Amendments to the Design Manual: Barrier Free Access 2008

(November 2012)

Figure 16A – Handrails of Staircase

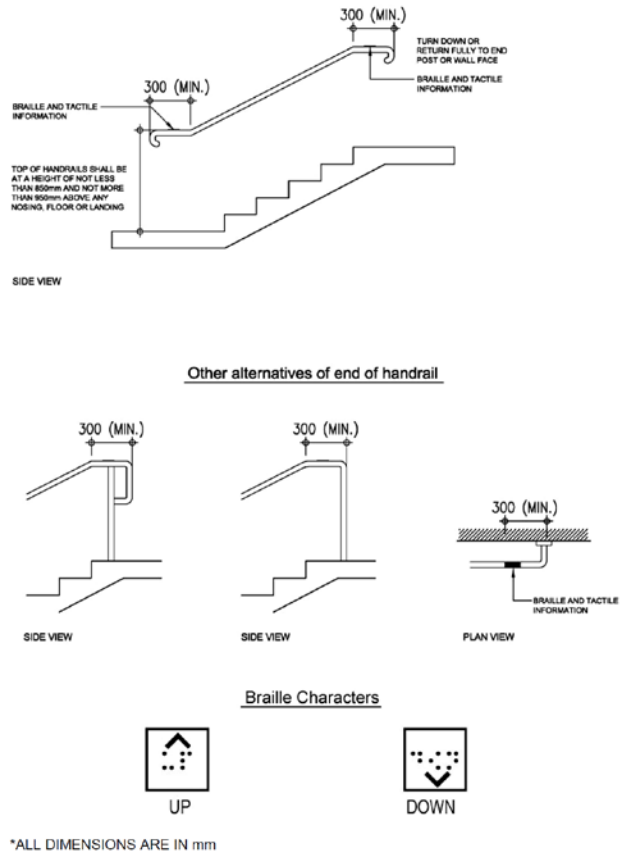
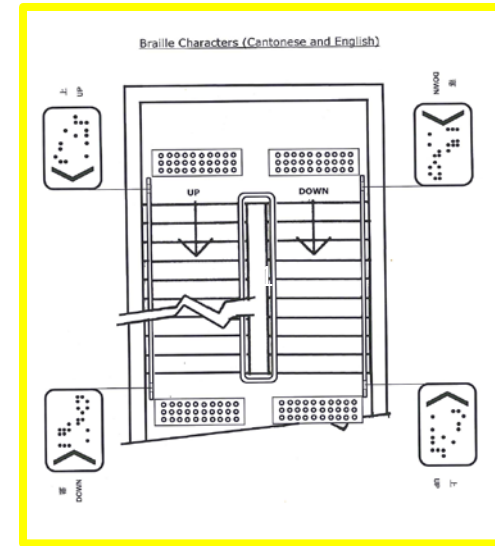
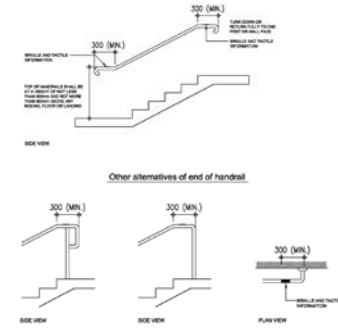
1. Figure 16A
(Paragraph
30 in
Division
8)@

Figure 16B – Handrail in Recess

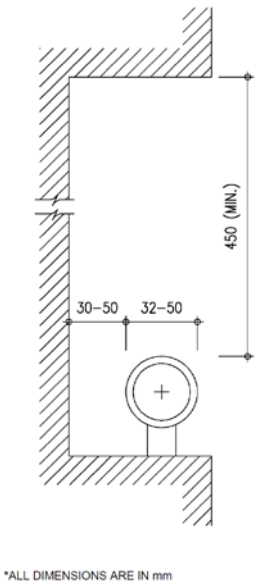
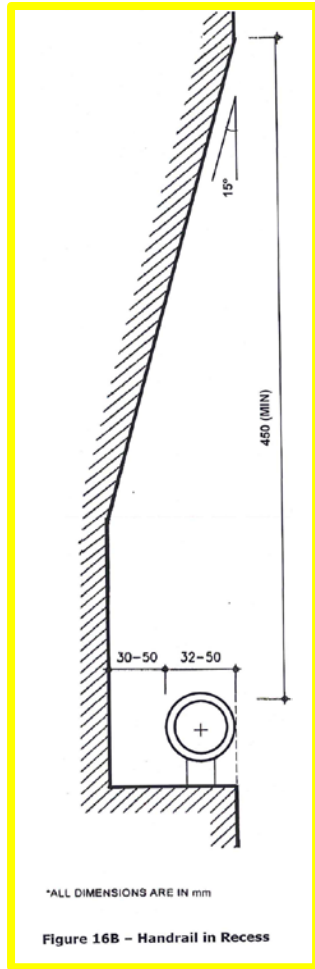
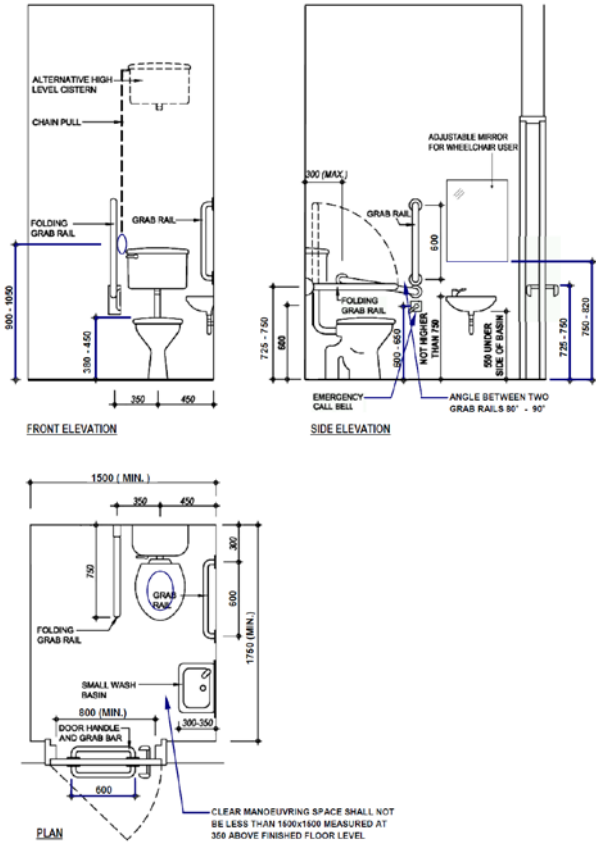
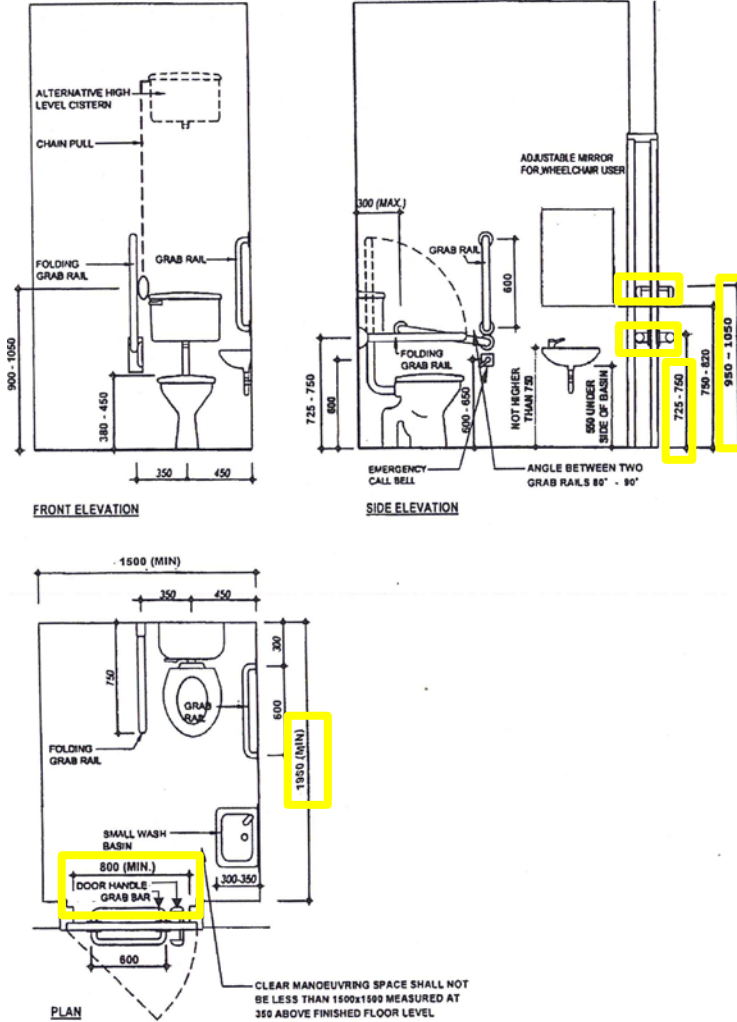
2. Figure 16B
(Paragraph
B(b) in
Division
8)*

Figure 24 – Accessible Toilet

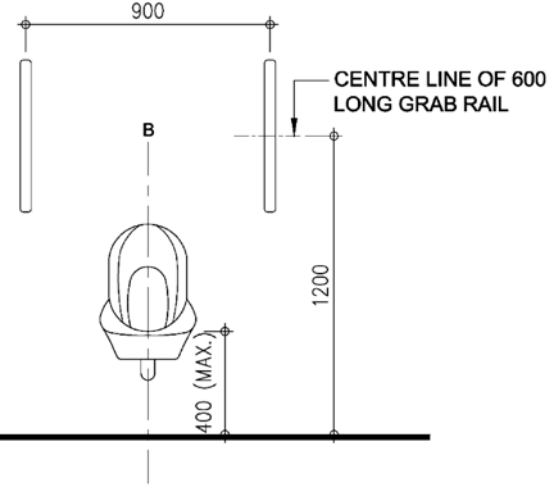
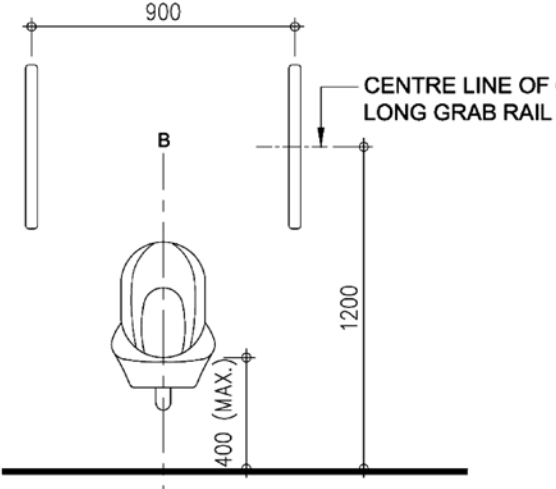
3. Figure 24
(Division
11)@*
